Capital Regional District

1. Implications of a Tsunami Wave on the McLoughlin Wastewater treatment Plant.

Re: Review of CRD Determination of Tsunami Wall Elevation for Proposed McLoughlin Point Wastewater Treatment Plant

RESIDUAL SOLIDS CONVEYANCE PIPE ALIGNMENT ON TOWNSHIP OF ESQUIMALT ROADS

Residual Solids Conveyance Pipe Proposed Alignment

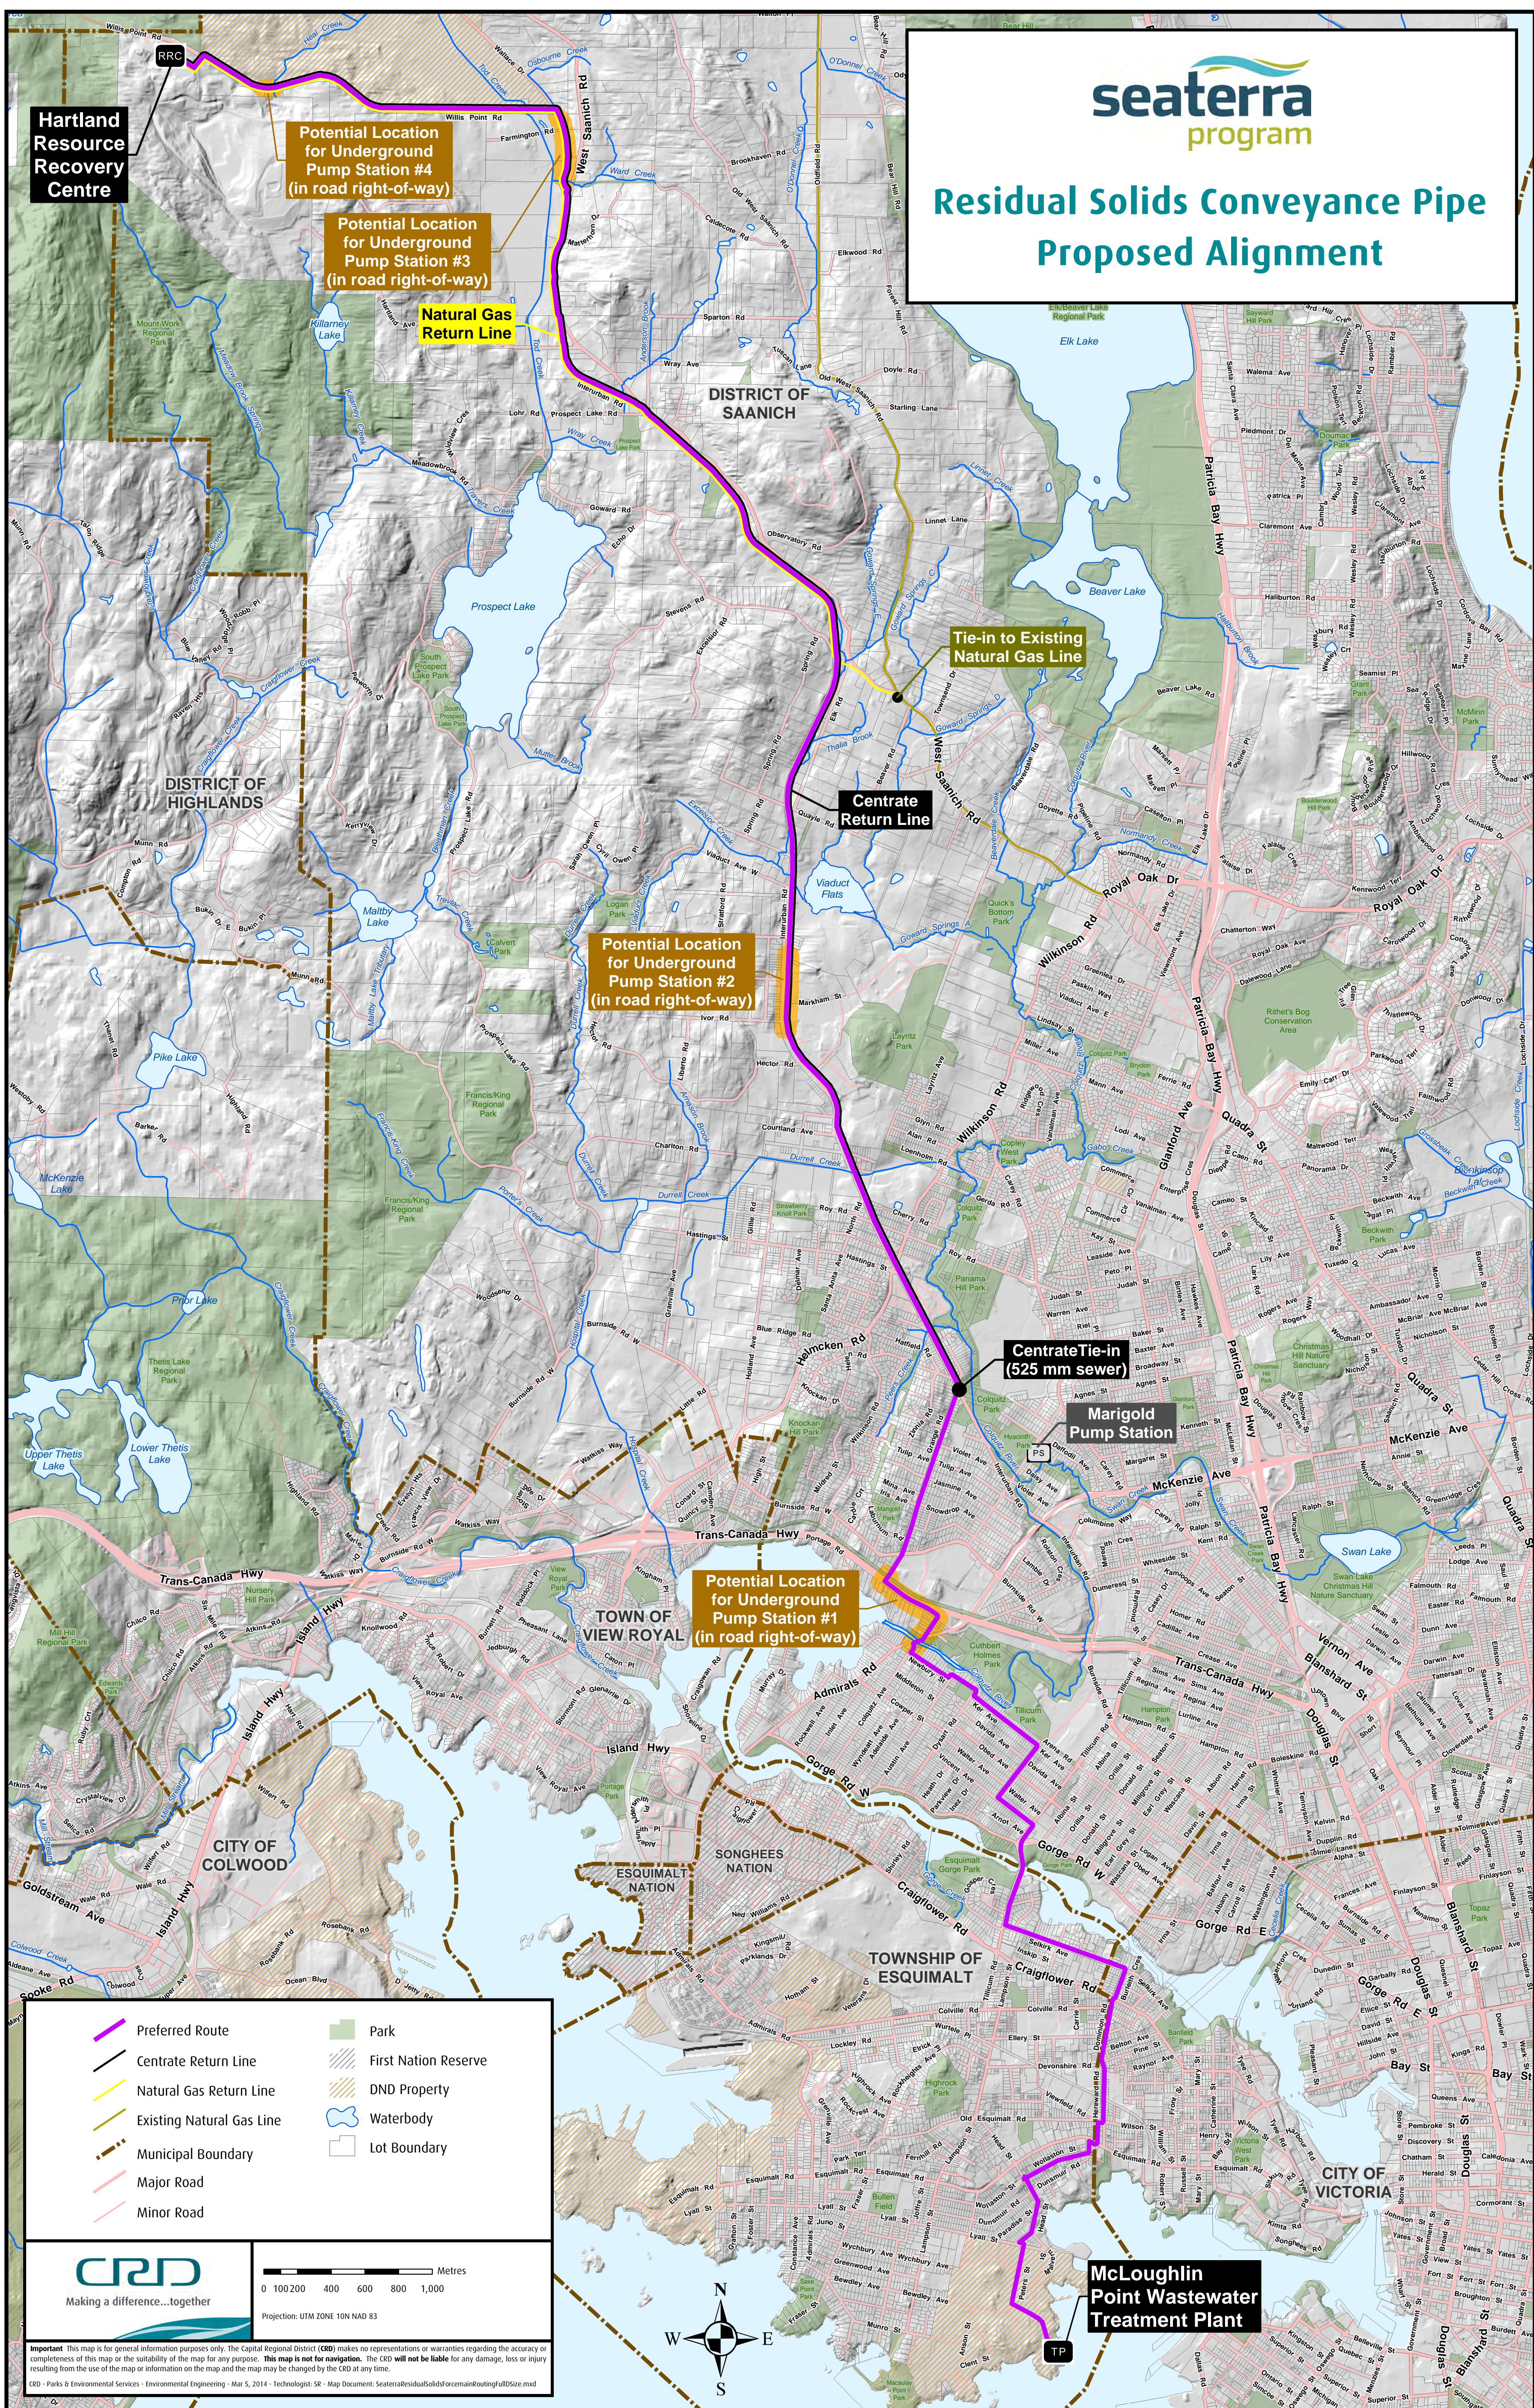
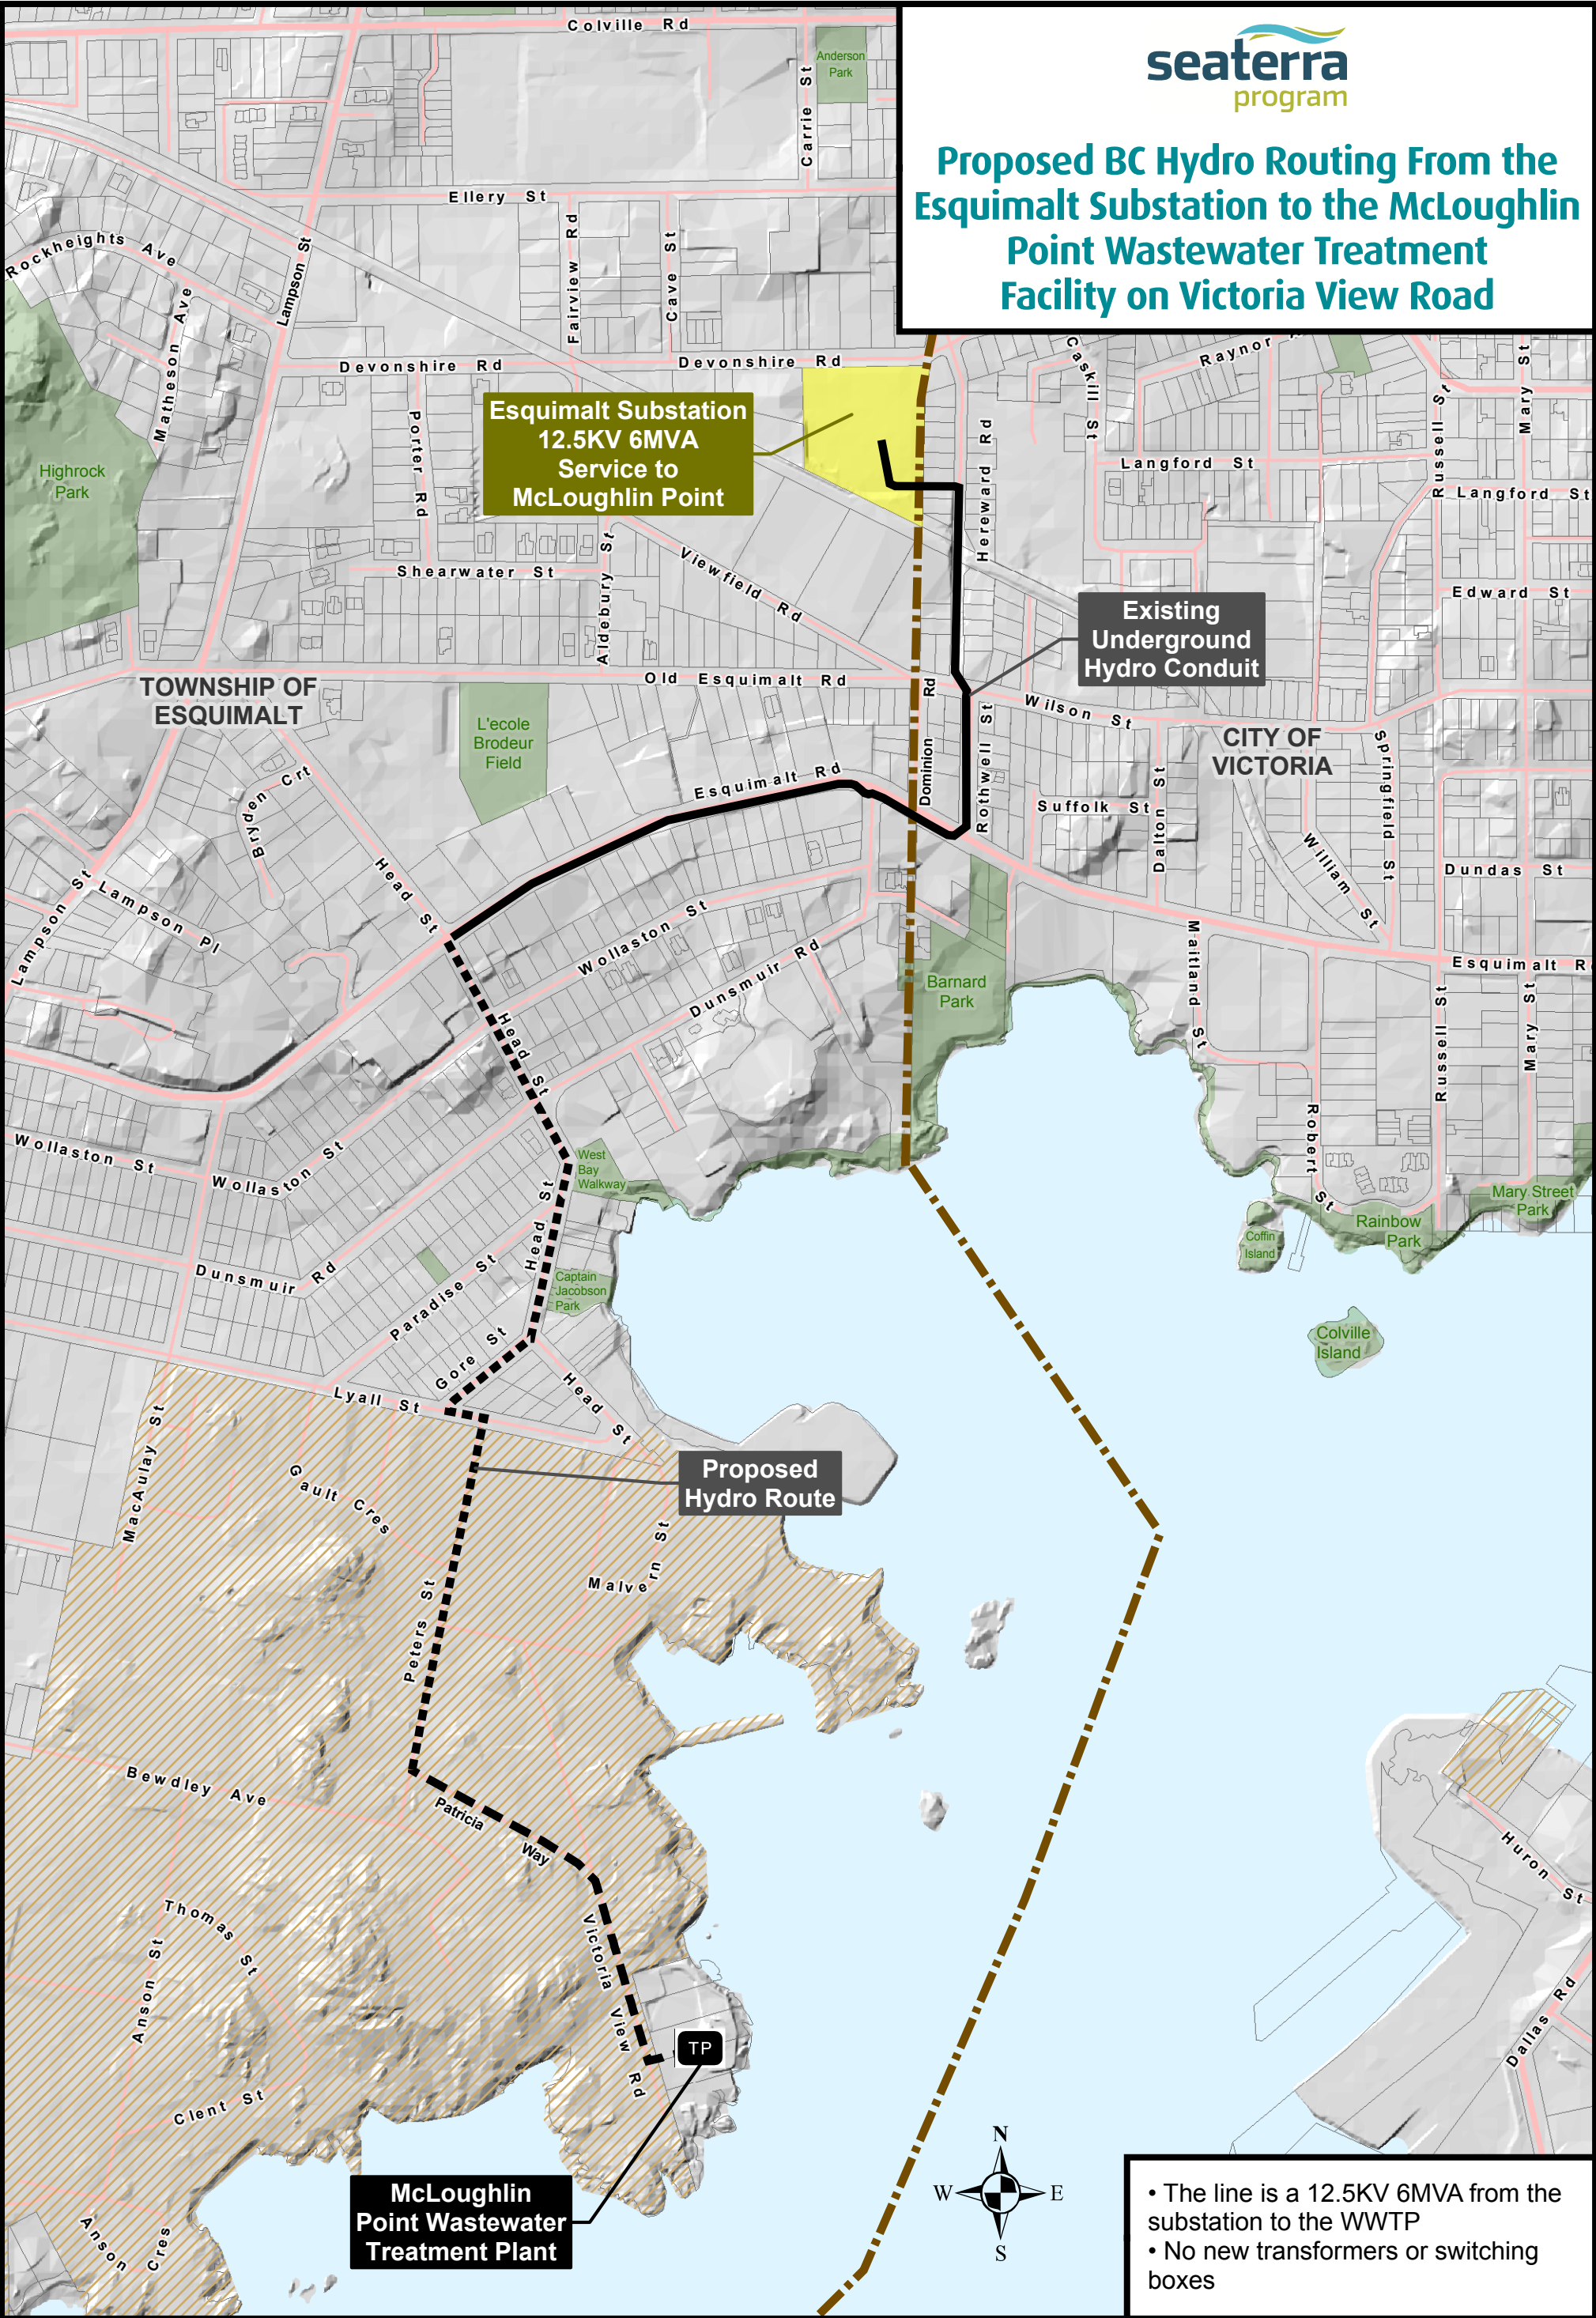
2. A map showing the route or possible routes of the biosolids conveyance pipeline to Hartland landfill.

The routing has been discussed in detail with Esquimalt Engineering staff and reflects their input. A map showing the route in Esquimalt and Victoria was officially submitted to Esquimalt on March 7, 2014 (Attachment 3). We have also attached a map showing the full route of the residual solids pipe from McLoughlin to Hartland landfill (Attachment 4). The pipeline route generally reflects the route shown in Amendment No. 8 to the Core Area Liquid Waste Management Plan (CALWMP) with adjustments to reflect the preferences from the Township of Esquimalt engineering staff within the boundary of the Township.

Further to the February 18 and March 5, 2014 meetings that Capital Regional District (CRD) staff had with Township of Esquimalt (Esquimalt) staff, we are writing this letter to confirm CRD's preferred conveyance pipe alignment in Esquimalt. The attached drawing identifies the proposed route which is located entirely within existing road right-of-ways. The route was identified by working together with Esquimalt staff to utilize a common corridor with BC Hydro and the proposed district energy system, and to minimize: rock blasting, arterial roads impacts, utility conflicts and avoid a railway crossing. Consistent with past practices, we request that Esquimalt Engineering review the proposed alignment to ensure that there are no engineering conflicts and to identify other capital plan works that we can coordinate with Esquimalt to minimize impacts to residents and commuters.
